## Technical design note

| Project name       | McDonald's Pontardawe                                                     |          |                          |
| Design note title  | Neath Port Talbot County Borough Council - Highways Observations Response |          |                          |
| Document reference | 15297-HYD-XX-XX-RP-TP-1003                                                |          |                          |

Figure 2.1: Flexible loading bay within site

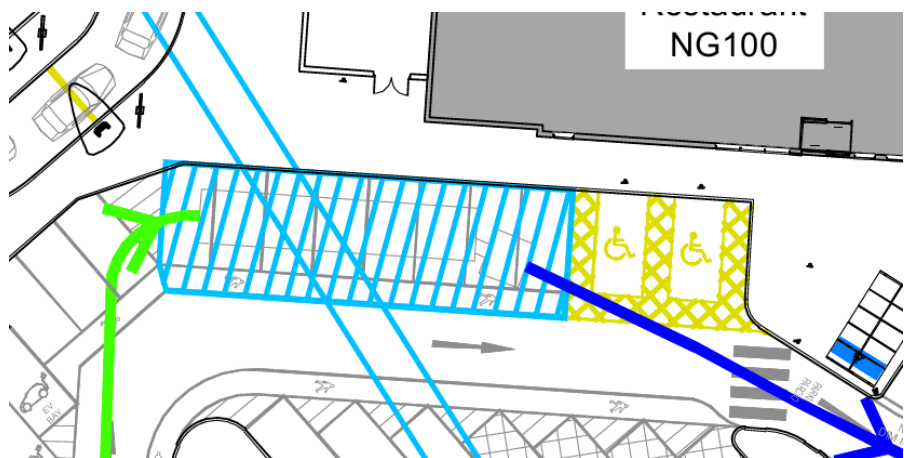
2.1.23 23. Deliveries to the bus bay are not supported as deliveries would need to be wheeled across active travel route a safe route to school and along island by EV charging points.

2.1.24 24. There are still concerns about the deliveries to bay numbers 16,17,18,19,20,21 and 22 as this is more than likely going to be a 24hr facility it could possibly lead to the loss of 5 parking bays while deliveries are being undertaken.

*Hydrock Comment - Deliveries would be undertaken to within the site using the parking bays hatched in blue below. This would be done outside the restaurant's opening hours, or during less busy periods. If undertaken when the restaurant is open, members of staff would act as banksmen. This could be included in a Service Management Plan that could be conditioned.*

*Hydrock Comment - There would be a strong commercial imperative for the restaurant to undertake any deliveries during less busy periods as any space blocking would affect income. It is not clear what the concern would be in relation to the very short-term loss of spaces during these quieter periods. In the unlikely event that no spaces were available at the site during deliveries, it is likely that customers would simply use the drive through instead or wait for a short time in the adjacent Tesco car park (which the officers acknowledge not to be fully utilised). Surrounding roads have parking controls in place and it is highly unlikely that any overspill parking would occur.*
